# Consultation on DS3 System Services Protocol Document

8 April 2020

The purpose of this paper is to provide an opportunity for stakeholders to provide feedback on the proposals to amend the DS3 System Services Protocol document – Regulated Arrangements, Version 2.0, published 1<sup>st</sup> May 2019.

Figure 1. Expected Response Characteristic

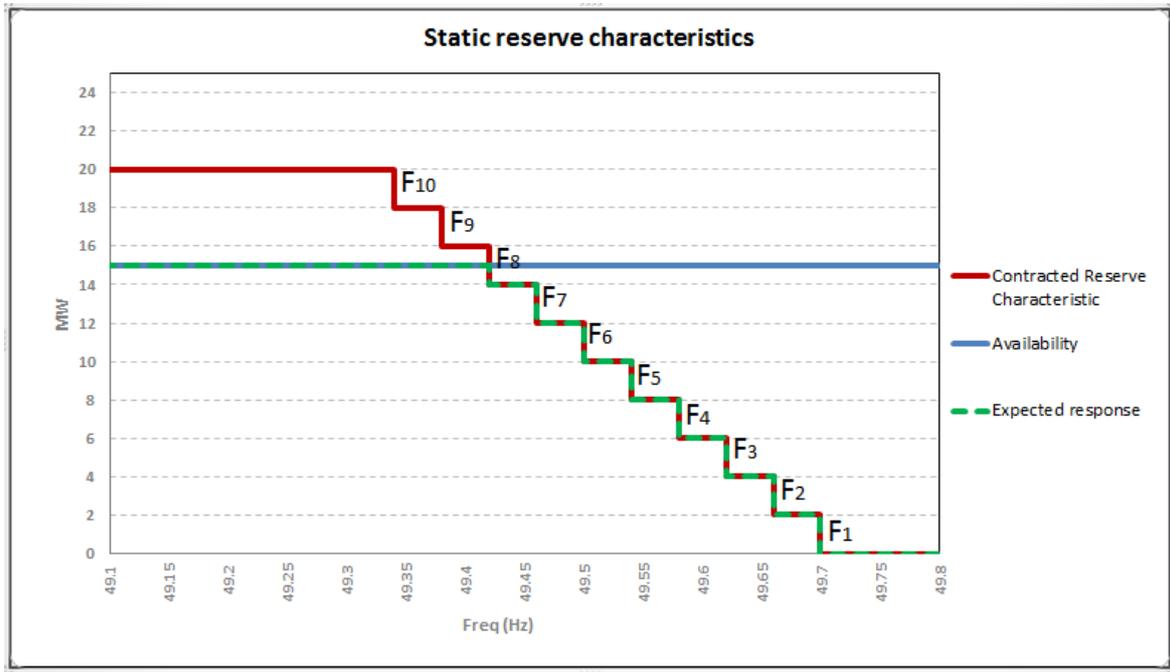
The TSOs propose to amend the Protocol document to provide clarity to industry regarding the expected response characteristics of FFR (Protocol document, Section 3.4) when the service is declared to a value lower than the Providing Unit’s contracted volume. This will bring the FFR service in line with the expected response characteristics of POR, SOR, and TOR1 as detailed in the current version of the Protocol document.

Industry has asked for clarity regarding what the response characteristics of a Providing Unit whose services are declared to an availability value lower than their contracted volume should be.

The TSOs’ requirement for a constant percentage droop, or constant MW/Hz characteristic, from system service providers is imperative for a number of reasons. Firstly, from a scheduling perspective, a constant percentage droop, or constant MW/Hz ensures that the response profile of the Providing Unit is predictable regardless of its availability declarations. Changes in availability result in a single axis movement in its reserve curve (a reduction in the MW expected to be delivered with no change to the expected MW/Hz characteristic of the unit up to that point).

The TSOs are updating the Protocol document to provide clarity, such that all service providers controllers should be set to provide a non-variable (but parameter setting) droop or MW/Hz characteristic, and that the response characteristic should be truncated in instances where the unit is unavailable to provide services at a level equal to their contracted volume, i.e. when services availability is reduced or declared down due to outages, technical issues, insufficient head room etc.
